responses to comments on former skeet range riwp (UNCLASSIFIED)

SUBJECT: Comprehensive Environmental Response, Compensation and Liability Act (CERCLA)/Interagency Agreement (IAG) Administrative Docket No. II-CERCLA-FFA-001-04: **Response to Comments on Former Skeet Range Remedial Investigation Work Plan, October 2010:** Review is ER-A eligible

**Response to NJDEP Comments from
Jim Kealy
Picatinny Former Skeet Range
Remedial Investigation, Draft Work Plan
Picatinny Arsenal, New Jersey**

**Response to EPA Comments on the
Former Skeet Range
Remedial Investigation Work Plan, October 2010
Picatinny Arsenal, New Jersey**

FIGURE 5
PROPOSED SAMPLE LOCATIONS

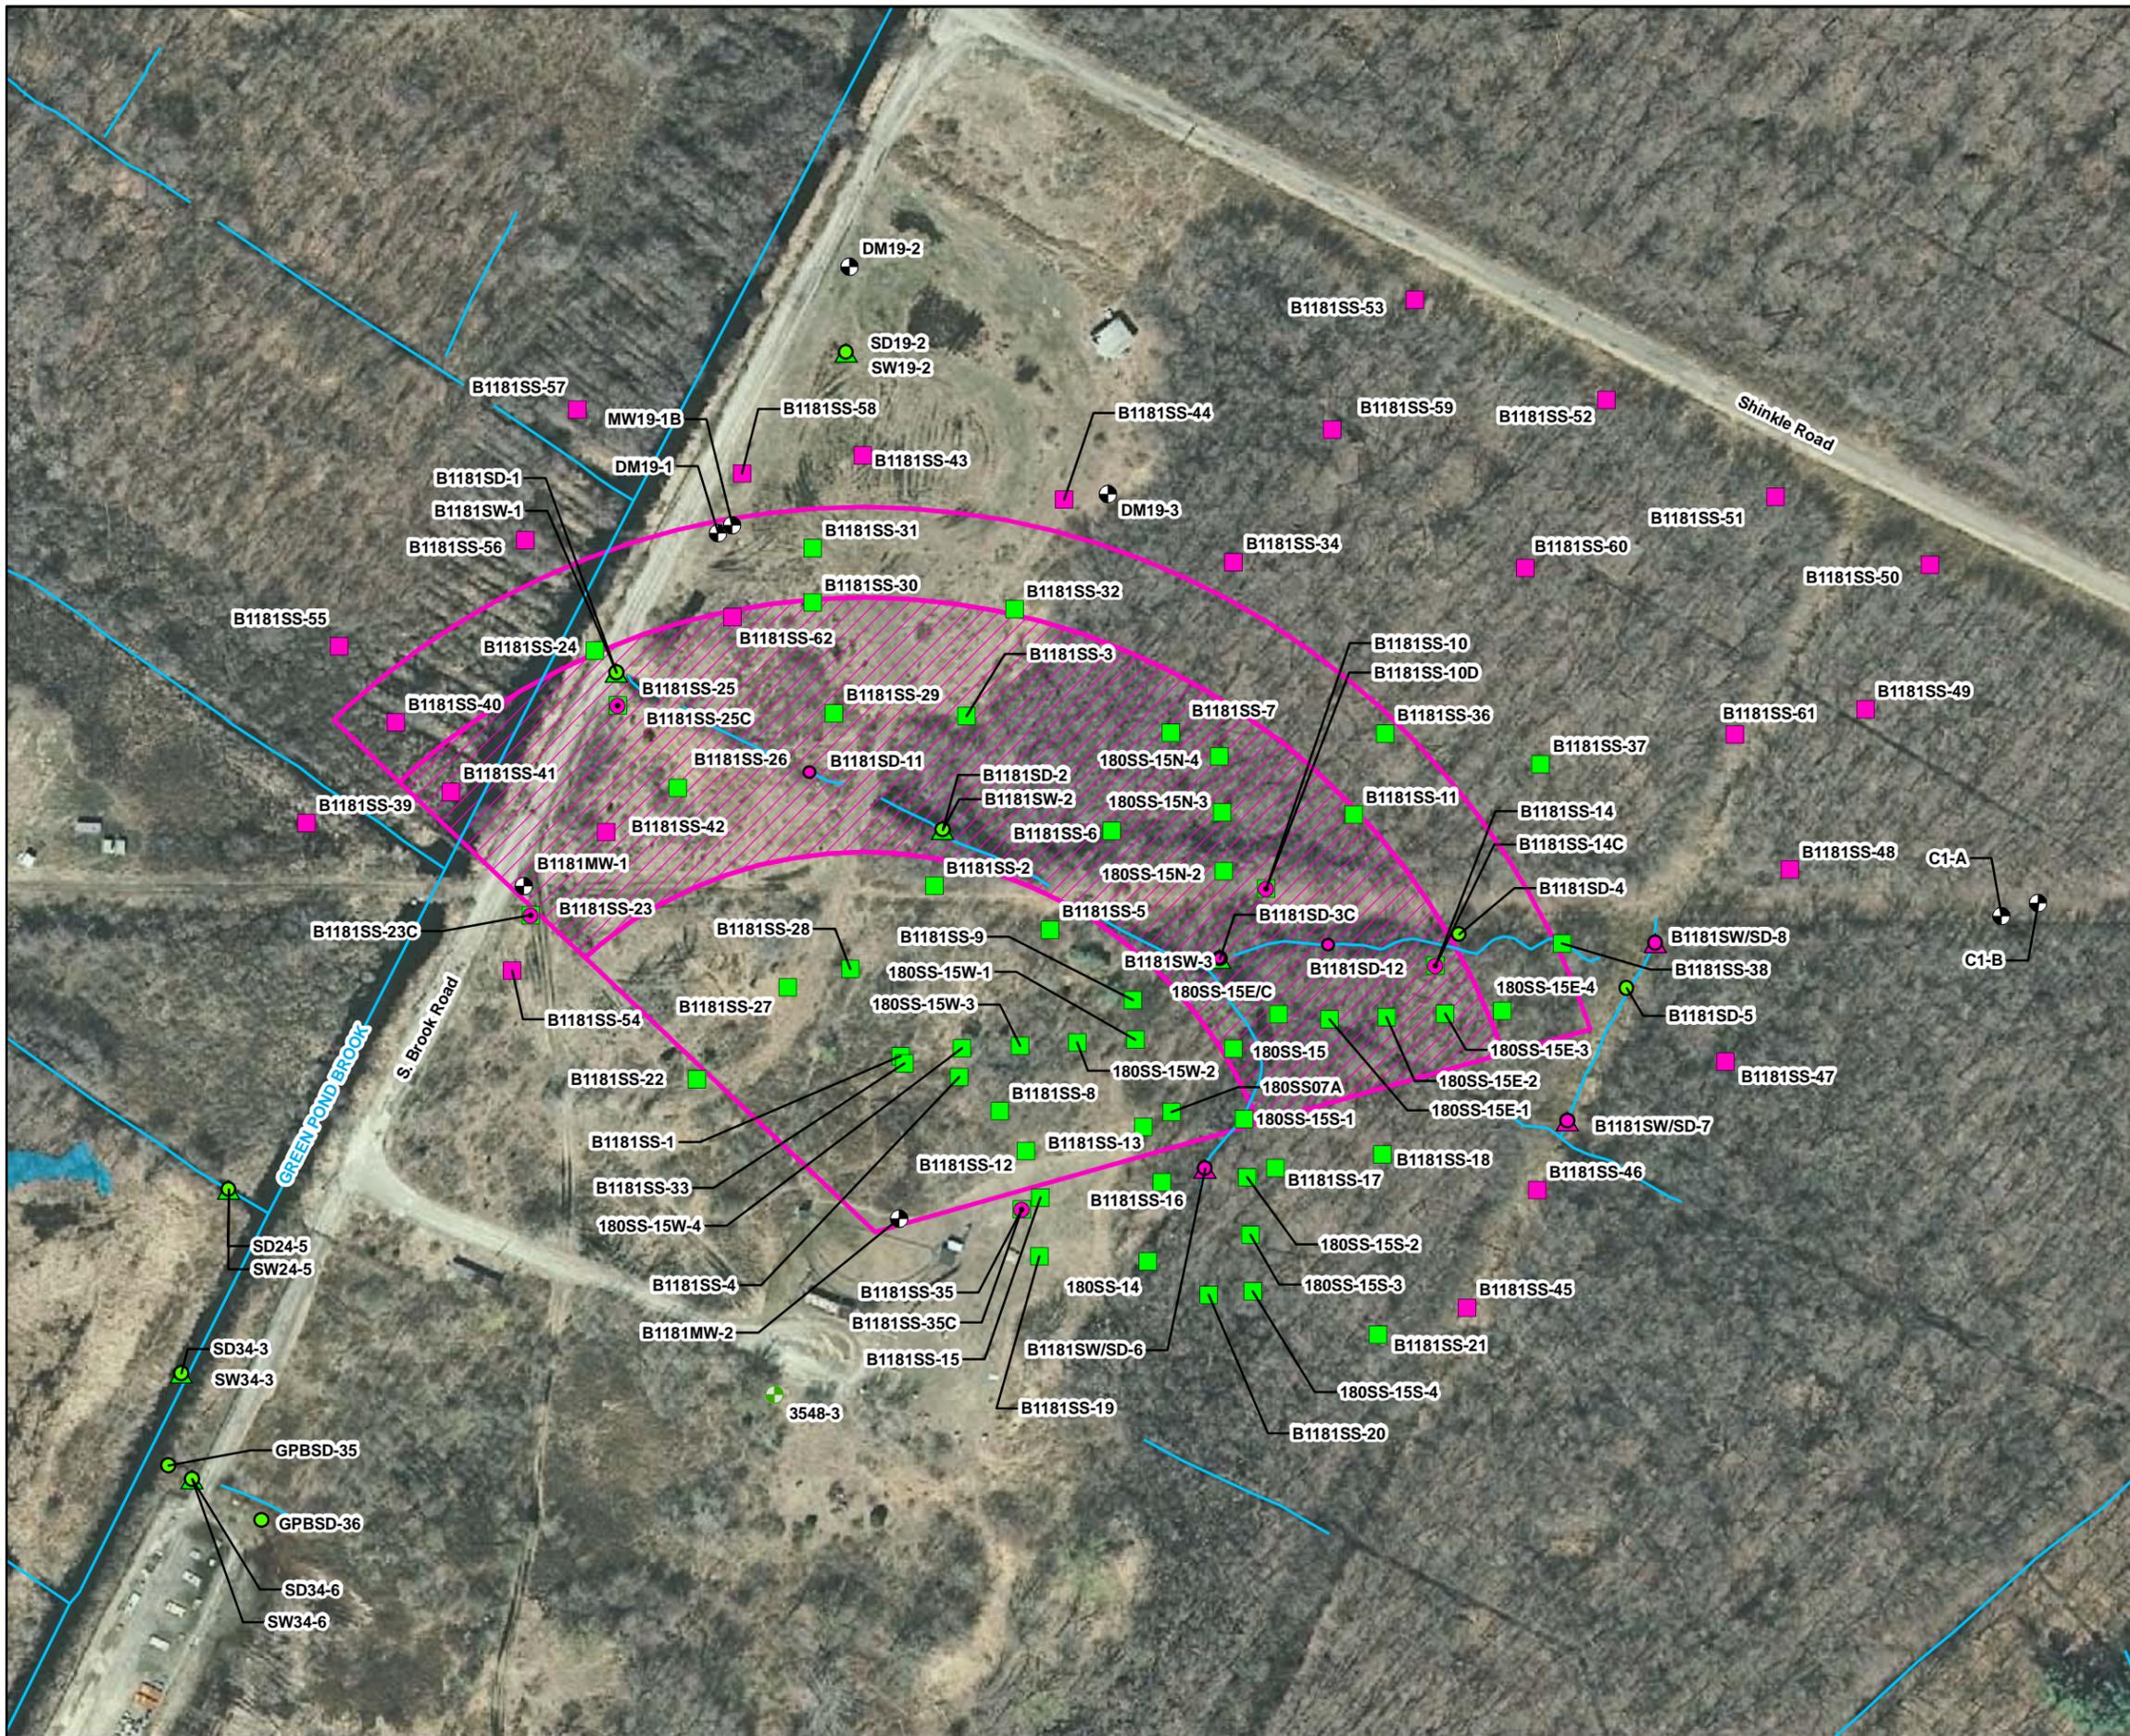
Comment: Based on my review, I have the following recommendations for additional surface soil sample locations and sediment for lead analyses to fill potential data gaps:

1. Surface soil (SS) midway between B1181SS-7 and proposed sample B118SS-51.
2. SS midway between B1181SS-34 and proposed sample B1181SS-53.
3. SS midway between B1181SS-37 and proposed sample B1181SS 49.
4. SS midway between B1181SS-31 and B1181SS-25.
5. Collect an additional sediment sample from the ditch midway between historic sample locations B118SD-1 and 1181SD-2.
6. Collect an additional sediment sample from the ditch midway between historic sample locations B118SD-3 and 1181SD-4.

Comment 2: Figures 2 and 6 use aerial photography as background for historical lead concentrations and proposed sample locations respectively. However, use of aerial photography for this purpose makes the figures difficult to read (green background and red sample symbols). Aerial photograph should be limited to a figure that shows site conditions and not sample locations, etc. In addition the purpose of Figure 4, 2010 Lead Sampling and Analysis Area, is questionable as it does not include previous sampling results. In determining the need for additional sampling, it would be helpful to place all sample results on one figure with contaminant iso-contours on a scale similar to Figure 3 from August 2010 Data Report.

Comment 6: Section 3.3, Surface Water and Sediment Sampling, Page 8: This section states that two surface water and sediment samples will be collected at random locations either within or adjacent to the former skeet range impact fan, depending on field conditions encountered and site observations during sampling. However, criteria for sample location selection have not been provided (e.g., should all conditions encountered be the same, how will the locations be selected). Revise the RI Work Plan to include the criteria that will be used to select the random sample locations.

Attached are responses to your comments on the Skeet Range. The submittal also includes Figure 5 with the additional sample locations based on the comments.

Enclosed for your review are the responses to your comments of the **on Former Skeet Range Remedial Investigation Work Plan**. This response also includes a map with the new sampling location based on your comments.

Response: The recommended samples in the northeastern operation of the site may be difficult to access, because the area is a marsh with pools of standing water and a high water table. Most of the samples in this area were purposely located near roads and fire breaks for safer access. Shaw personnel will attempt to collect the requested samples; however, if the locations cannot be safely accessed and sampled, the sample will have to be eliminated. It should be noted that for all these recommended samples, downgradient samples have been or will be collected, so horizontal delineation will be characterized. These additional samples will be analyzed for lead only.

Response 2: It is assumed that the comment is referring to Figures 2 and “5”, instead of Figures 2 and “6”. The sample locations in Figures 2 and 5 are clearly distinguished. The modern practice in consulting is to use Geographic Information Systems (GIS) with aerial photograph

Response 6: As stated in the 2010 data report and RIWP, field conditions within and around the former skeet range can vary and present safety concerns. These concerns include standing water, iced over ponded water, phragmites, etc. These items were the basis of choosing the additional surface water and sediment samples at random locations. In addition, two additional sediment samples (B1181SD-11 and B1181SD-12) will be added within the skeet range impact fan based on comments from the NJDEP. Figure 5 will be revised in the RIWP with these new locations.
